## **2 Deerbrook Trail - Application for Fence Exemption**

**From:** Acting District Manager, Municipal Licensing and Standards, East District

The Applicant for 2 Deerbrook Trail has requested Scarborough Community Council to allow the proposed fence and exempt their property from the following by-law requirements:

# Attachment 1: iView Map of Property – 2 Deerbrook Trail- City of Toronto.

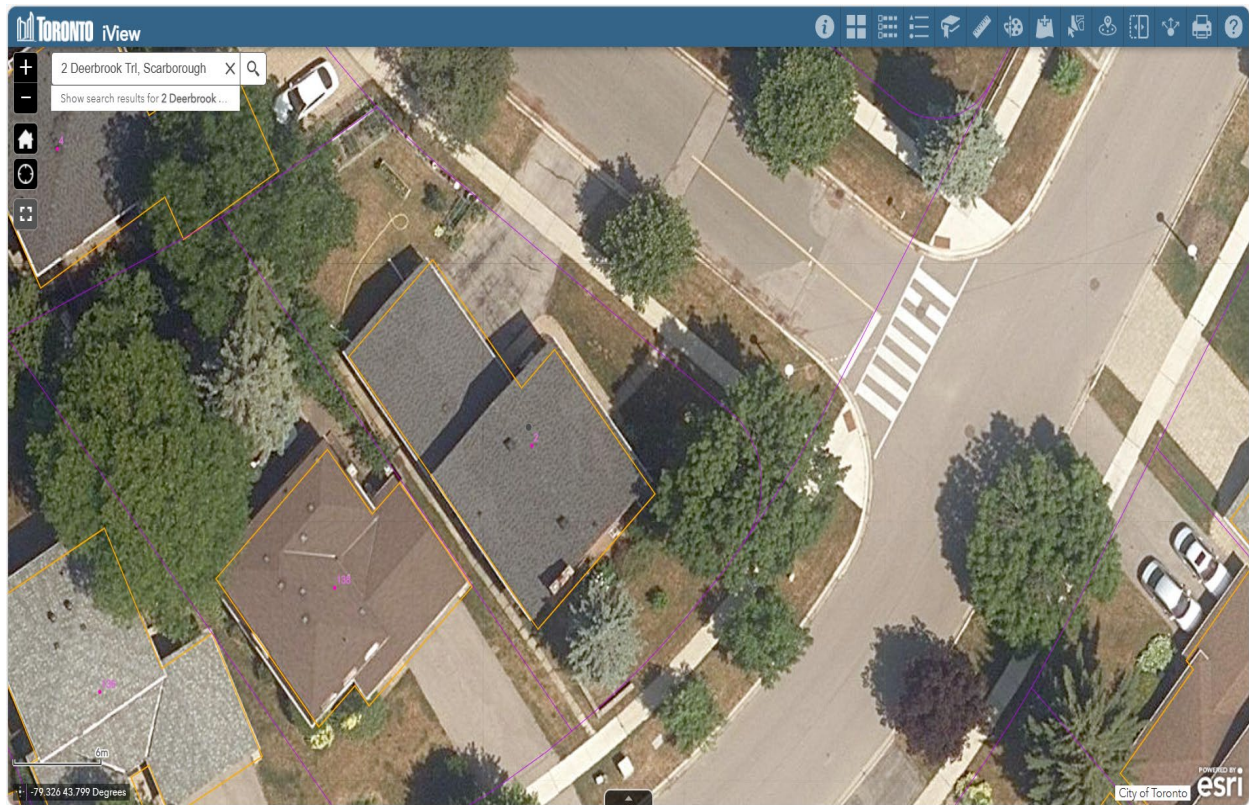
The proposed fence in the front yard on the south side of the property has a height of 2 meters. This is higher than the allowable 1.2 meters.

The proposed fence in the rear yard on the northeast corner is within 2.4 meters of a driveway and is not made of open-fence construction.

The proposed fence in the rear yard on the southeast corner (of the rear yard) is within 2.4 meters of a driveway and is not made of open-fence construction.

Refuse to grant an exemption to Chapter 447, Fences, to the property owner of 2 Deerbrook Trail, for the existing fence described in the Summary of this report
